ISOLA SW ALASKA
4400 SW ALASKA STREET

DESIGN REVIEW
DPD #3014486
FEBRUARY 6, 2014

ITEMIZED RESPONSE TO EDG BOARD COMMENTS

EDG PLAN OF CORNER UNIT

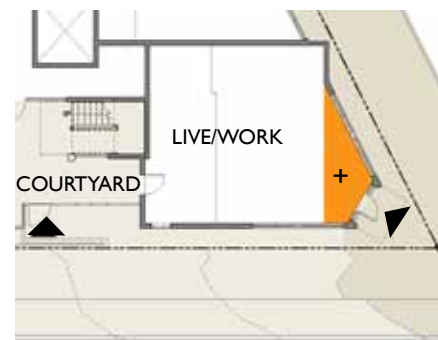
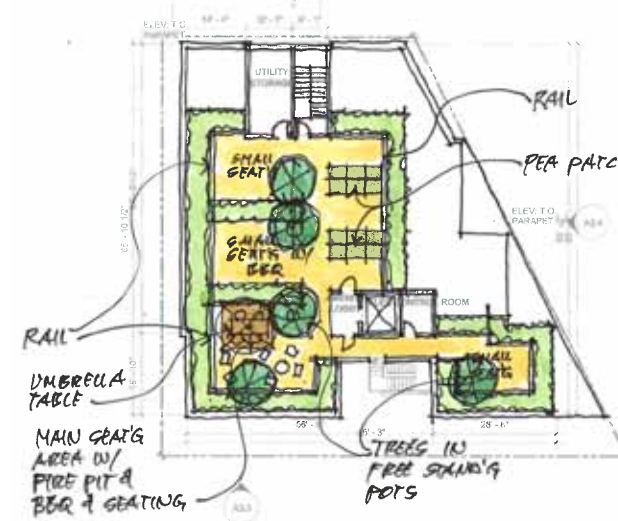
The board discussed the importance of the corner and provided suggestions:

- increase the size of the space and develop a sense of height to create a tall space
- differentiating it from the residential portion
- utilize fenestration, material and landscape so that the corner reads as commercial
- the corner treatment should resolve itself within the overall architectural concept

Massing studies in design development were directed toward emphasizing the corner with the intent of differentiating its use from the residential portion of the building while integrating it with the architectural concept. This is accomplished with a diagonal commercial element with unique material and window application that cuts through the residential sawtooth at the lower levels. The area of the corner unit was enlarged to bring a tall, transparent entry out to the corner, with a materiality that speaks to its commercial use.

STAIR DESIGN

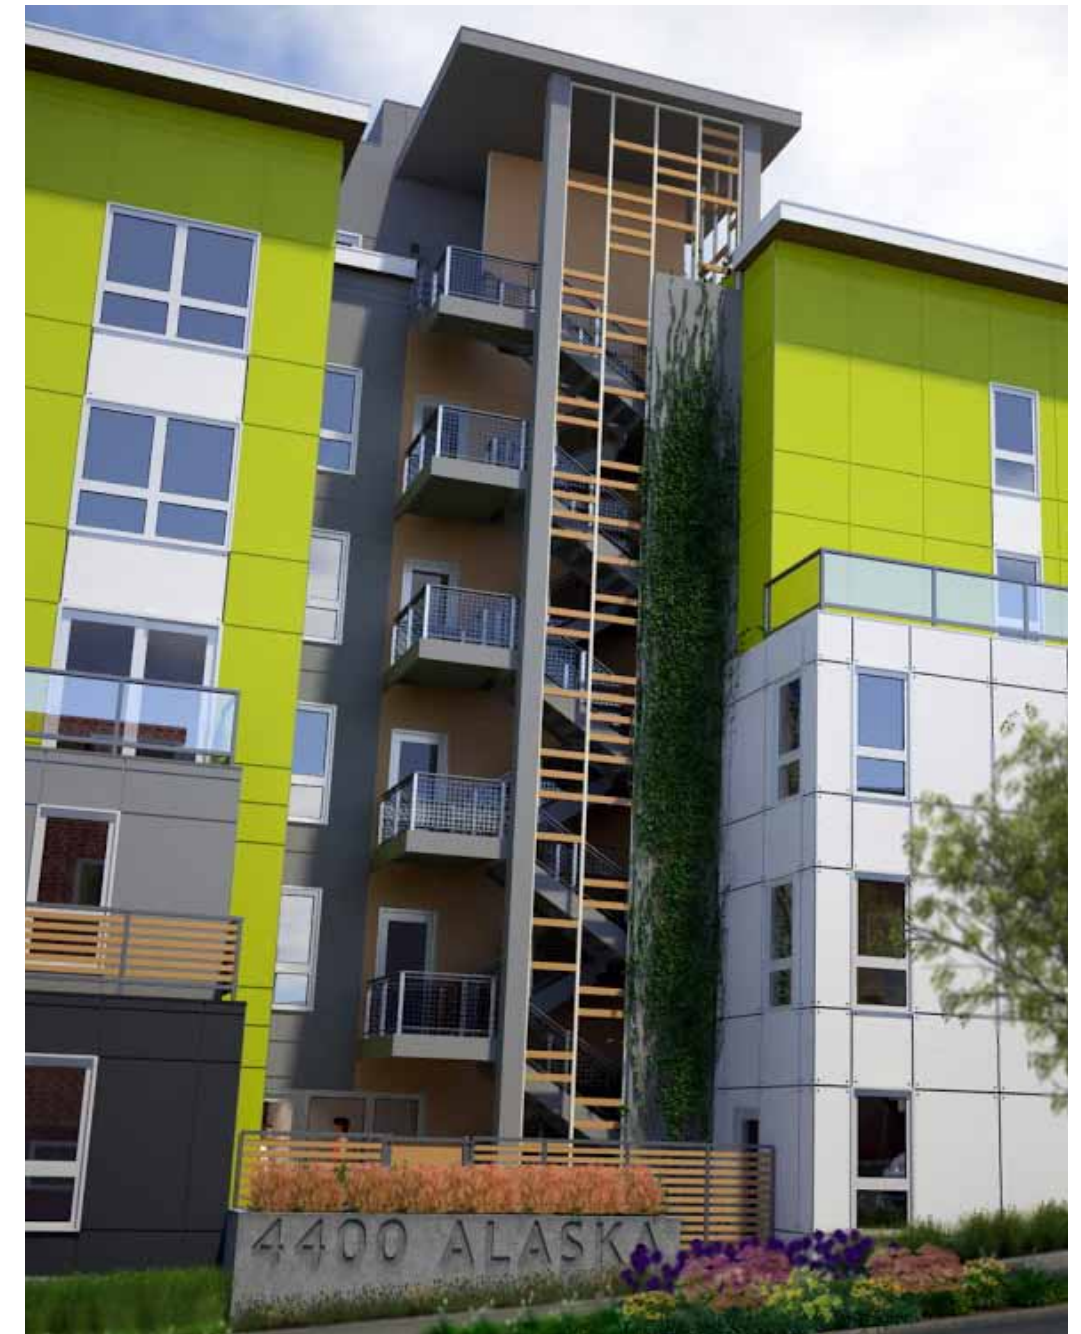
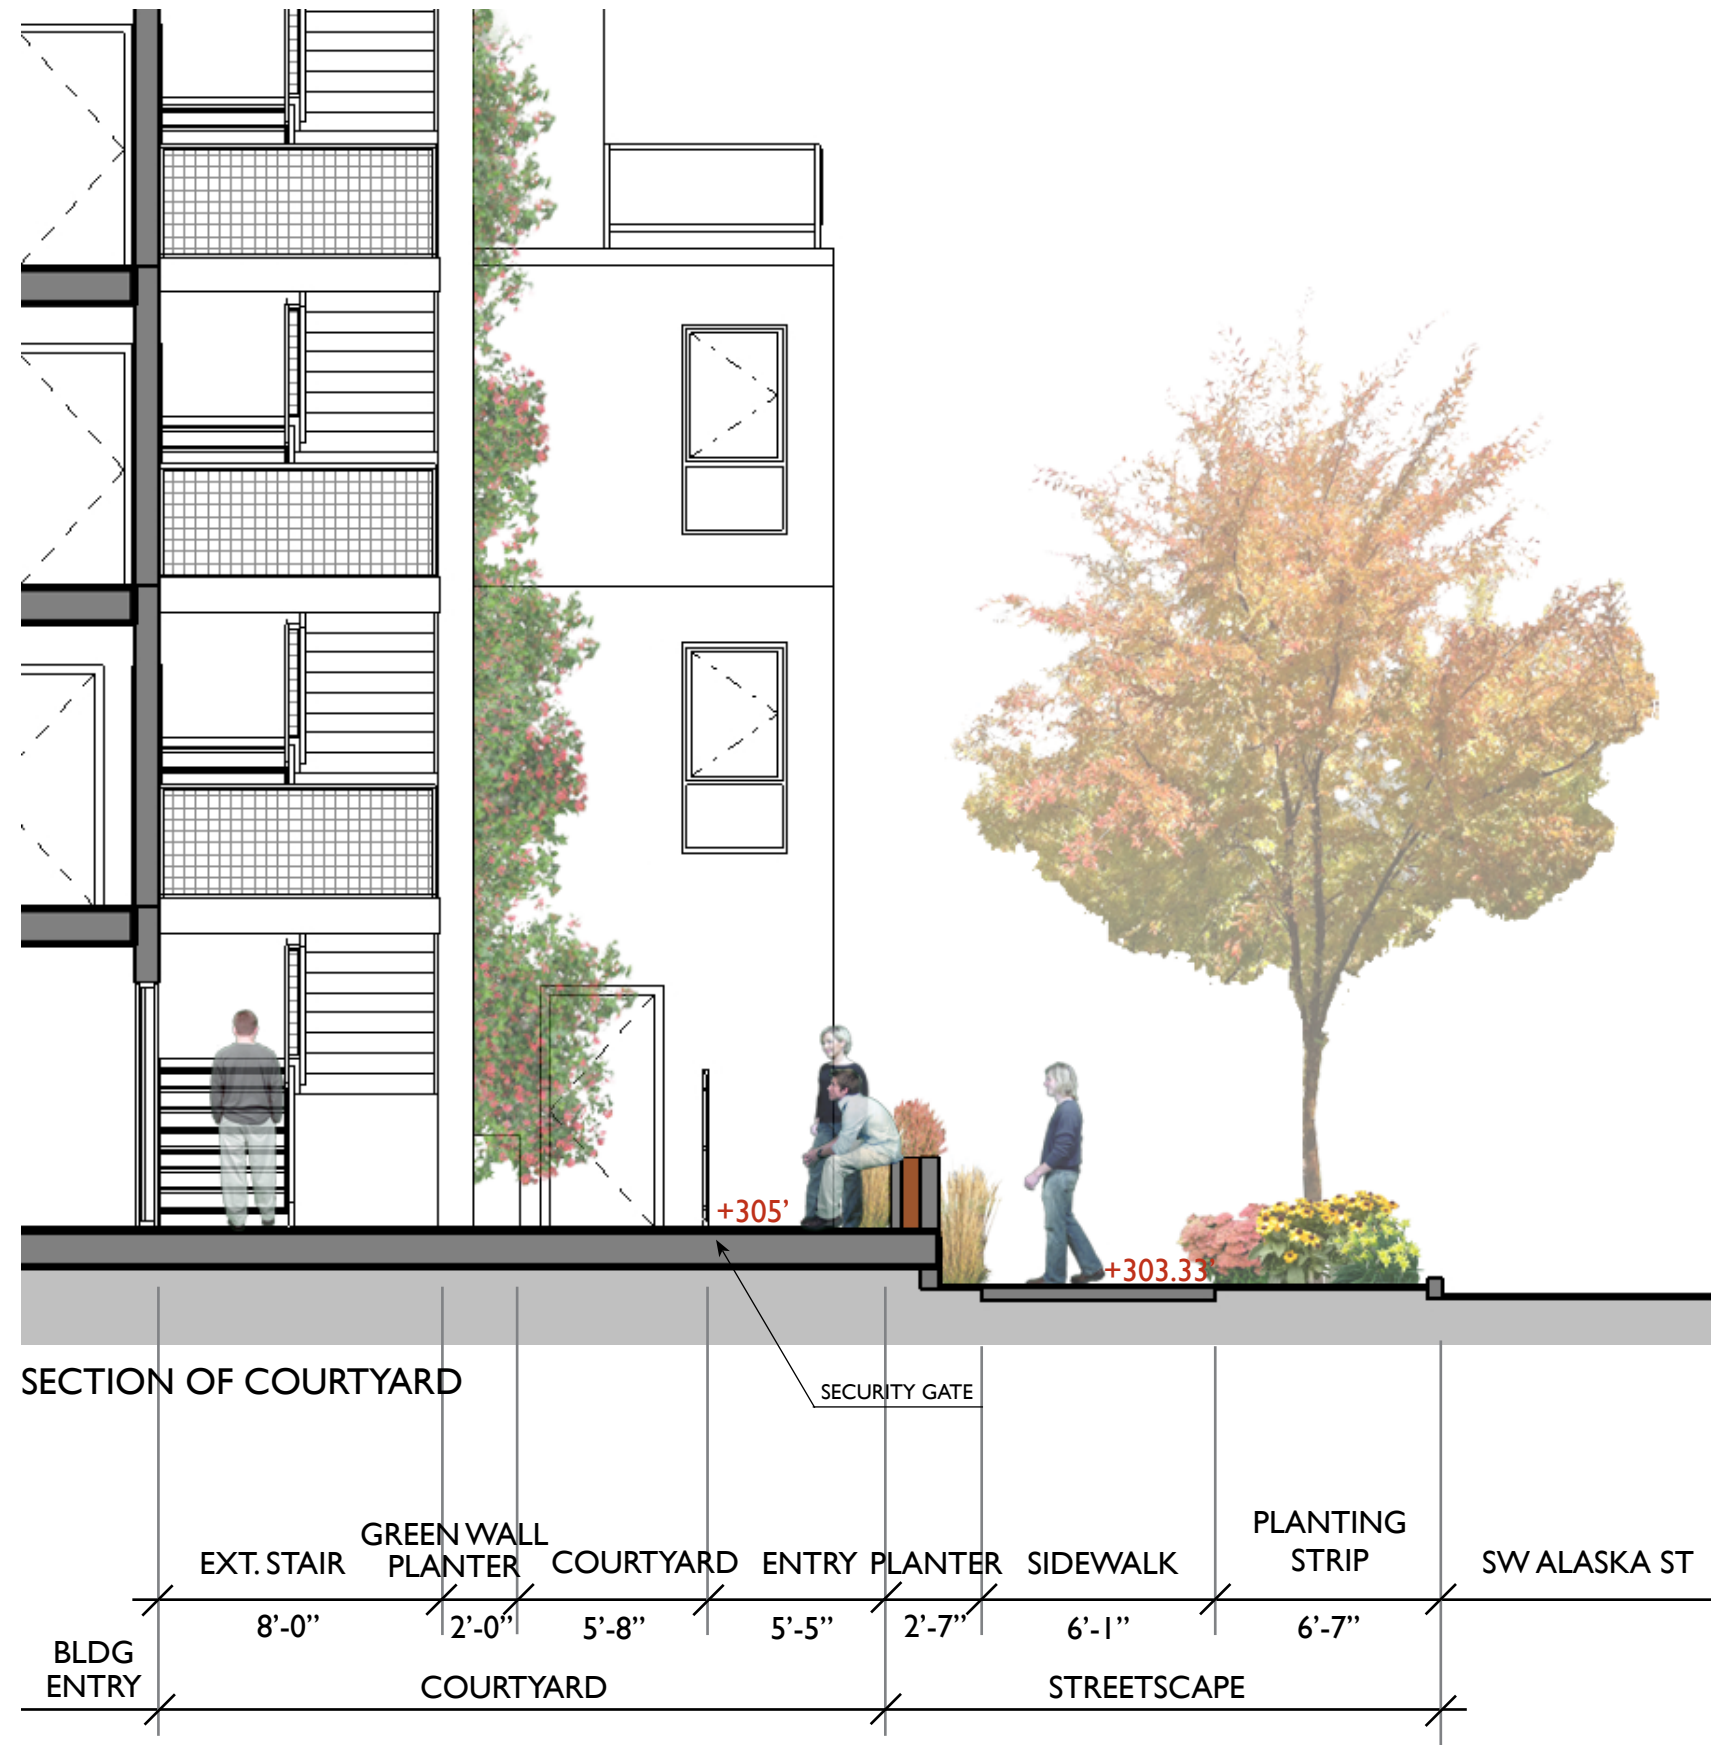
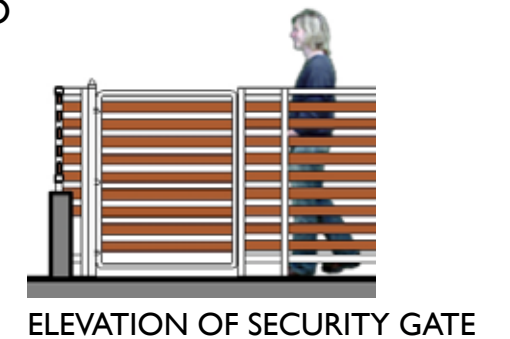
The Board was supportive of an entry security gate for the courtyard that is visually permeable to the pedestrian sidewalk experience and was also supportive of a partially open staircase, suggesting that it should have roof cover for weather protection. Design suggestions for the exterior stair included: integration with the overall building concept, quality materials, and consistency of stair articulation to the rooftop termination.

The Board comments were appreciated, and great attention was given to the stair and courtyard as a central design element. The courtyard is entered via a walkway parallel to the sidewalk that negotiates the steep sidewalk slope into an accessible entry. The entry is wrapped with a concrete planter with attractive landscaping that acts as a low, permeable barrier from the sloping sidewalk. The courtyard is enclosed with a semi-transparent wood slat fence that provides security for residents.

The stairway has been developed as a central sculptural design element. The wood slat material echoes the wood slat found at the courtyard fence and the southwest balconies. It is partially exposed, yet protected with a large wall with integrated vertical landscaping. A flat roof with overhangs reinforces the language of the overhanging eaves on the primary building roof.

EDG BOARD REQUESTED: STUDY OF SOUTHWEST UNIT STOOP ENTRY FROM SIDEWALK

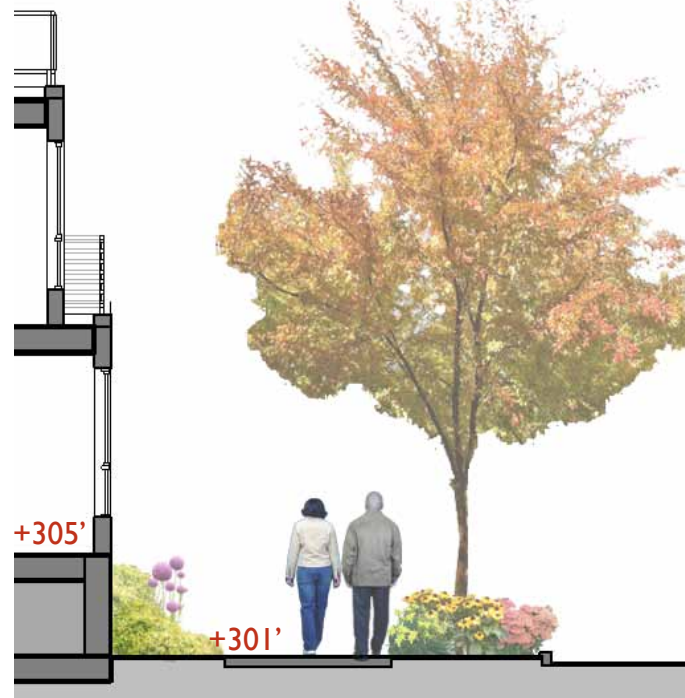
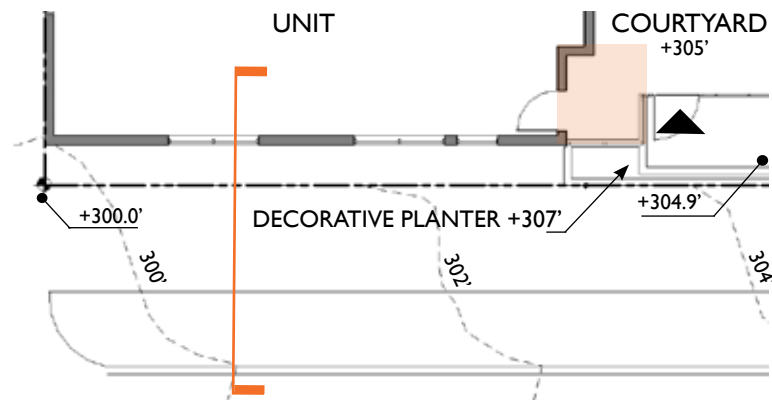
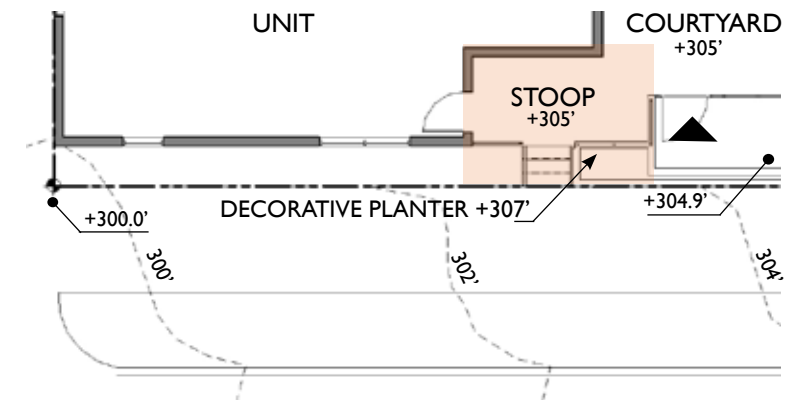
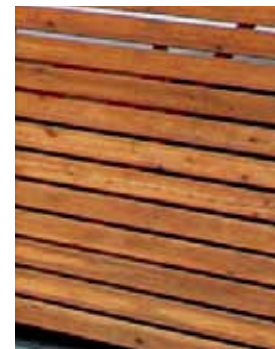
The board concluded that the uses and ground plans should relate to the existing sidewalk grades while providing a cohesive architectural concept. They suggested studying the southwest corner residential entry, with a stoop, for the residential unit along SW Alaska Street. The Board noted the entry should be designed to provide a direct relationship between the unit and the street to encourage human interaction while also providing security and privacy for residents.

At the Early Design Guidance meeting on June 27, 2013, the board encouraged the study of a separate entry at the sidewalk with a stoop for the residential unit at the southwest corner along SW Alaska Street. The board noted that the entry should be designed to provide a direct relationship between the unit and the street to encourage human interaction while also providing security and privacy for residents.

A study of the entry at the southwest unit found that although a stoop provided an additional connection to the building from the sidewalk for that particular unit, it disrupted the overall concept of a courtyard entry and disrupted the regular massing. After careful study, a preferred scheme locates the entry to the southwest unit via the courtyard, affording the tenants a private, secure entry. A relationship to the sidewalk is created with large windows overlooking the sidewalk.

After careful study of the options, it was determined that by locating the entry off the courtyard, the resident would have the greatest sense of security and privacy while still having some transparency through a slatted wood fence. Additionally, locating the entry off the courtyard created a greater length of facade for windows. The windows provide a relationship to the street, but maintain privacy by their elevation above grade.
